SEWAGE DISPOSAL SYSTEM

HOWARD COUNTY HEALTH DEPARTMENT

REPAIR - PURPOSE - TO REPLACE FAILING SEPTIC SYSTEM AT TENANT HOUSE. Currently 3 houses reportedly on 1 common septic system.

RE: PERCOLATION TEST RESULTS

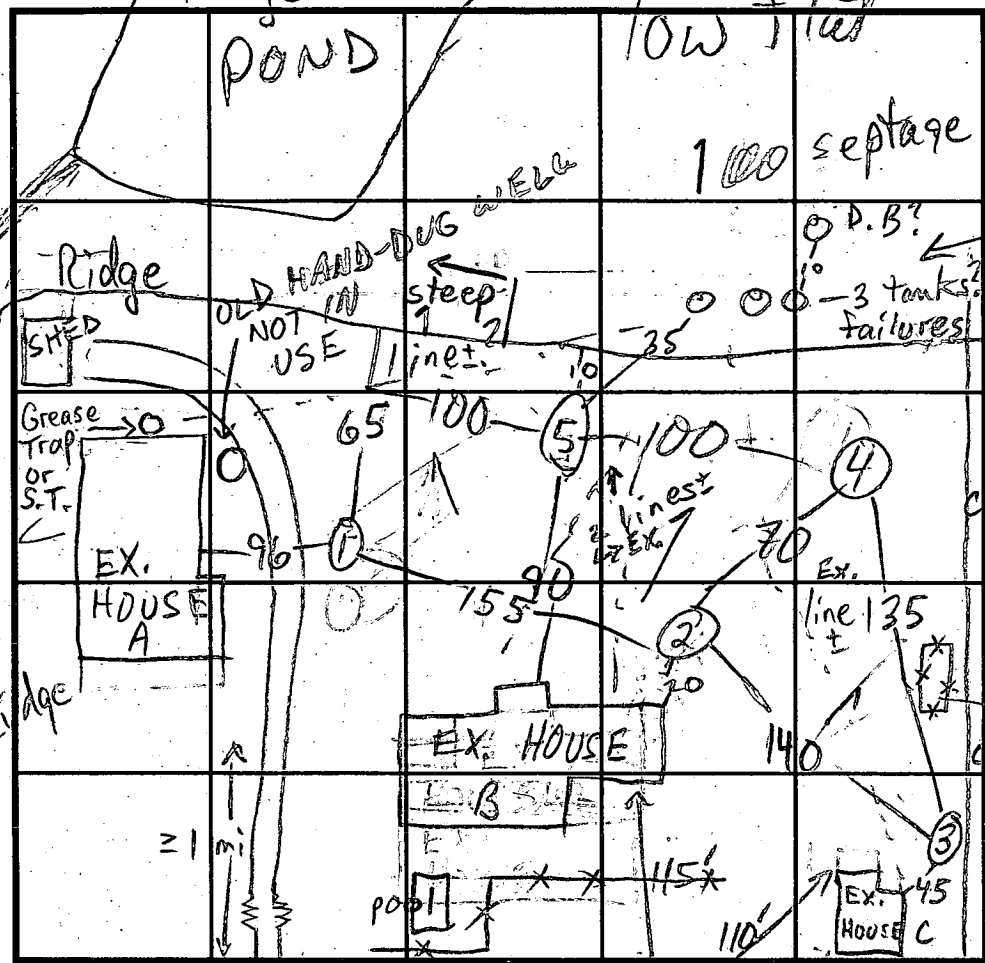
EX. SYSTEM TO BE ABANDONED DUE TO POOR RELATIVE ELEVATIONS TO POND

REMARKS AREA ESTABLISHED ~80' x 300', SHOULD BE ~20-24 K
